Attachment 3 – Effect of Fully Penetrating Wells

Attachment 3 Figure 3-1 NRC model-predicted potentiometric surface in Zone 2 with long-term operations at Selected Modules in Zone 3 and Zone 4

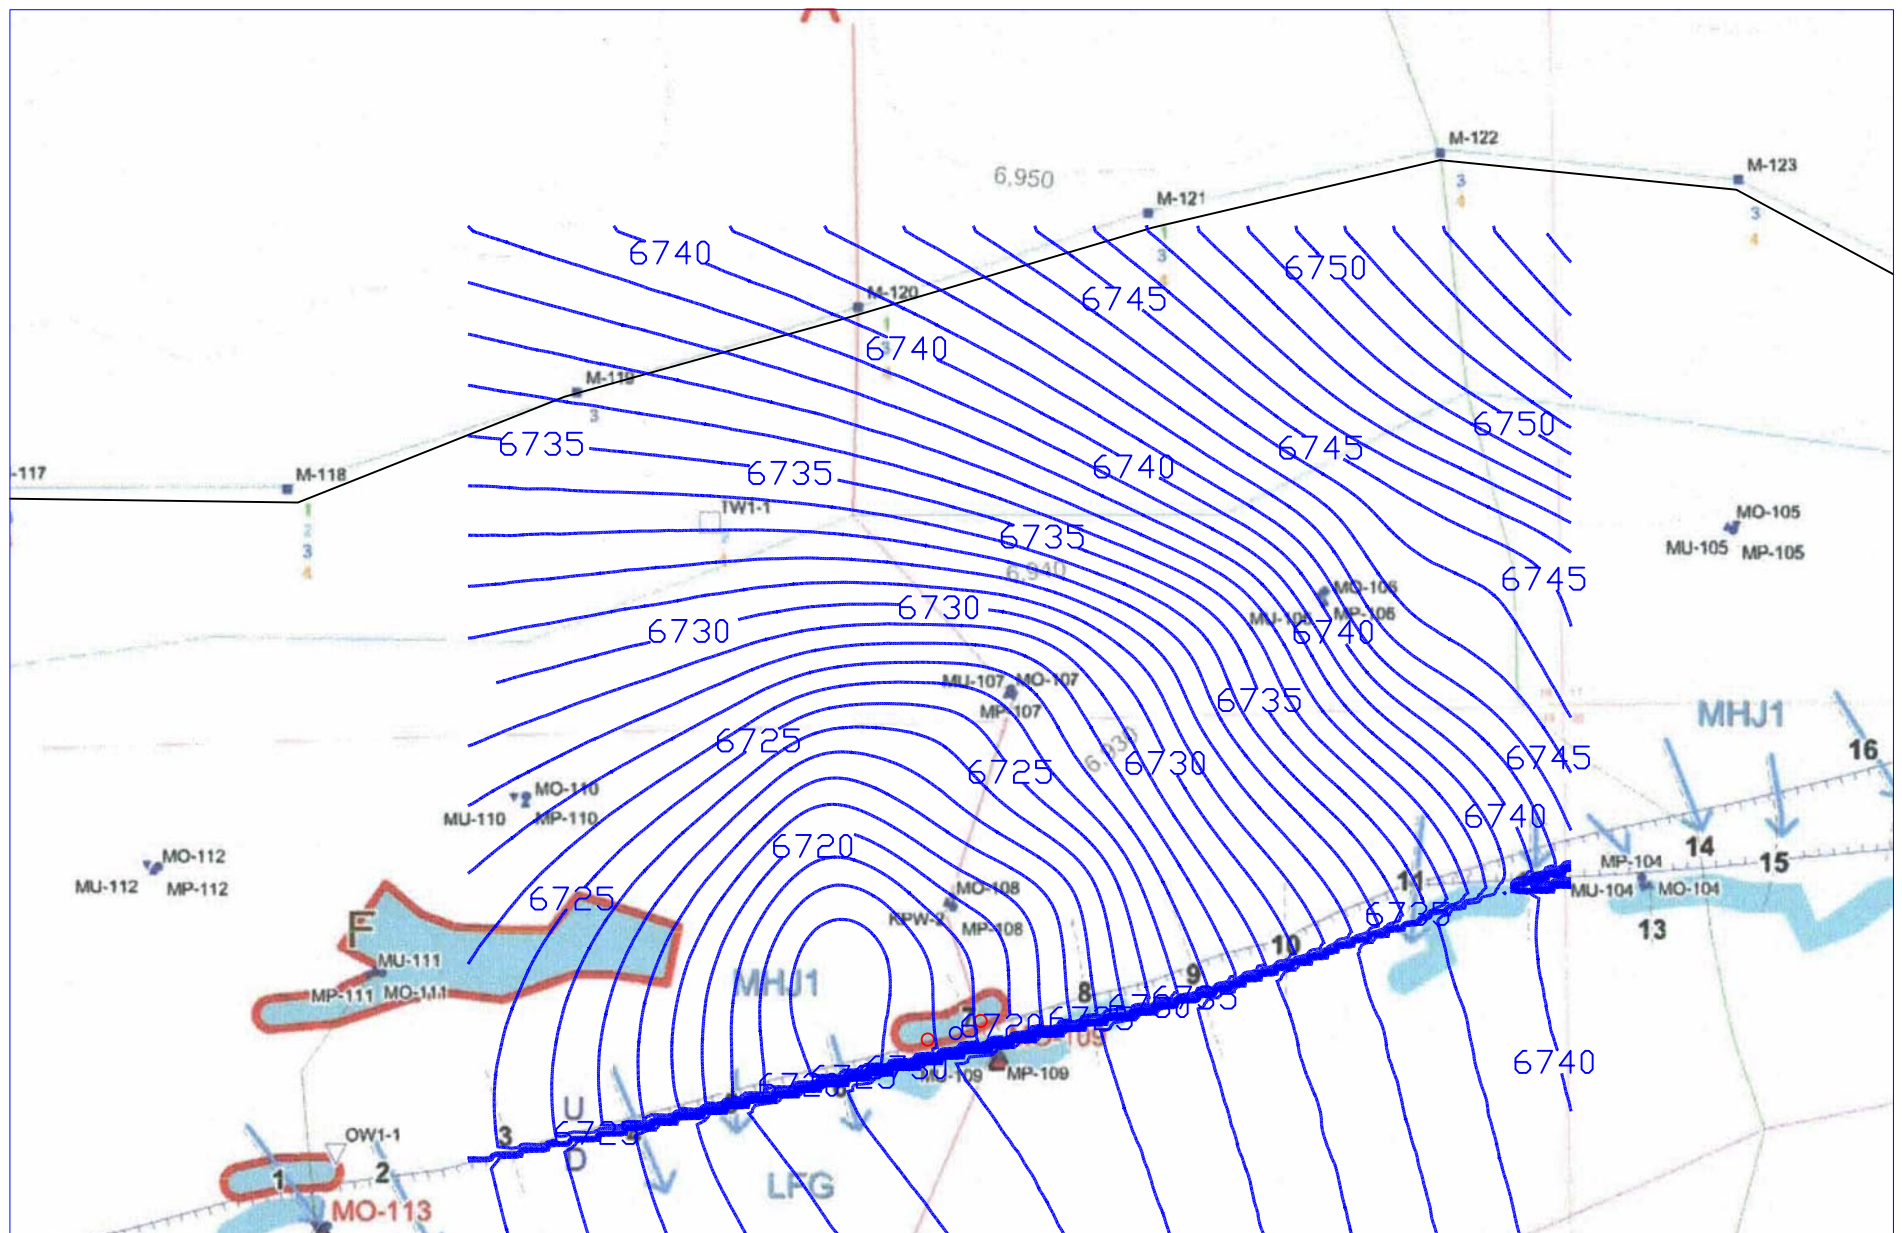
To verify the expected impact, staff used the AEM Model discussed in Attachment 2. A contour map of the model-predicted potentiometric surface in Zone 2 under normal long-term operations in Zones 3 and 4 is shown on Attachment Figure 3-1. The contour map shows that the potentiometric head is depressed in part from the operations in Zones 3 and 4; however, a west-southwestern gradient is maintained in Zone 2.

A comparison between Attachment figures 3-1 and 3-2 show area of minor depression in the vicinity of non-operating well PW-102. The minor depression indicates increased communication with Zone 3 through well PW-102. If well PW-102 was located closer to an injection well, the connection may result in the migration of lixiviant from Zone 3 to Zone 2.

Lost Creek does not propose monitoring, does not specify corrective actions should such a scenario develop nor provide details on well abandonment.

Attachment 3 Figure 3-2 NRC model-predicted potentiometric surface in Zone 2 with long-term operations at Selected Modules in Zone 3 and Zone 4 and fully penetrating wells LC19M and PW-102

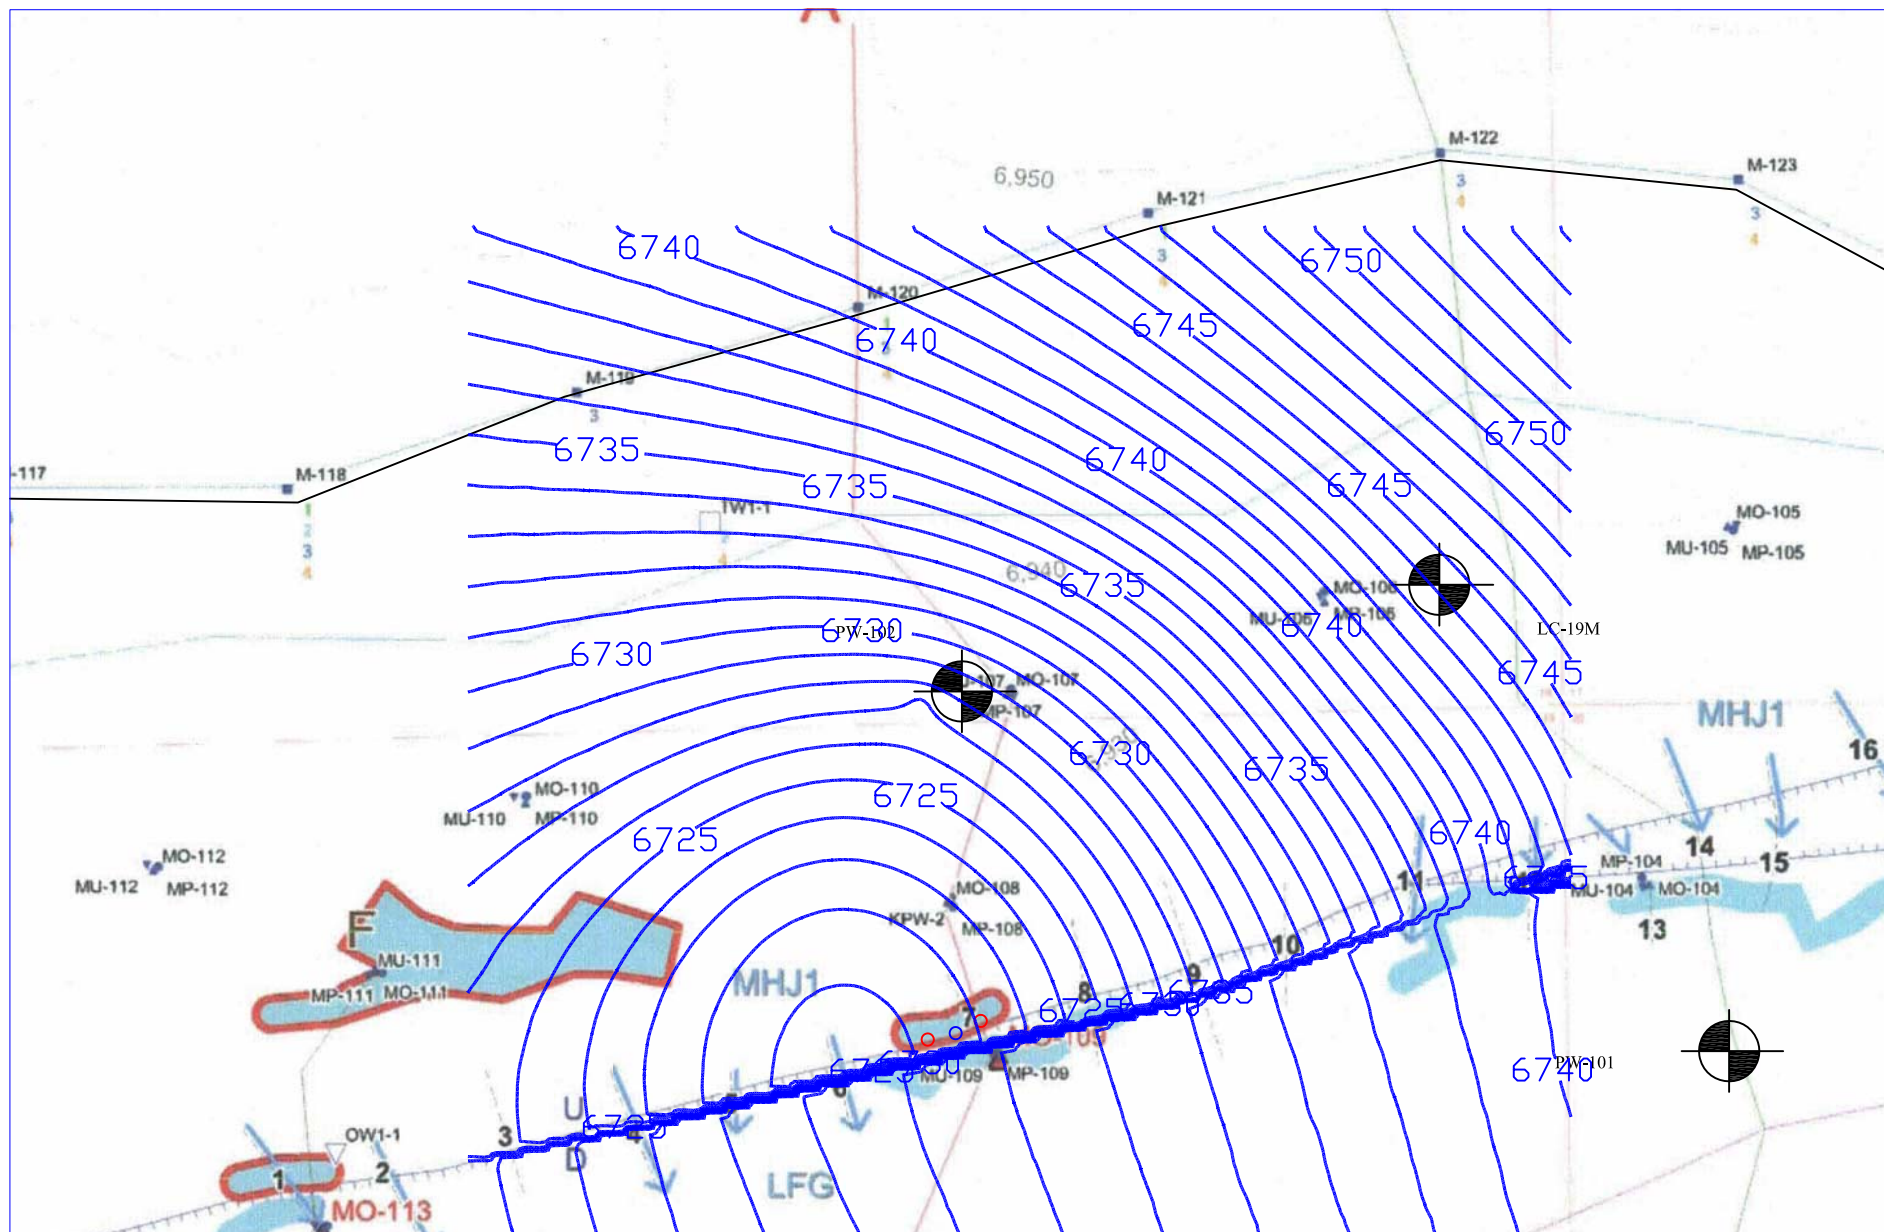
Non-operating wells were added to simulate wells PW-102 and LC19M (for the revised model input, see Appendix 3-A). A contour map of the model predicted potentiometric surface in Zone 2 under long-term operations in Zone 3 and 4 with the non-operating wells is shown on Attachment Figure 3-2.
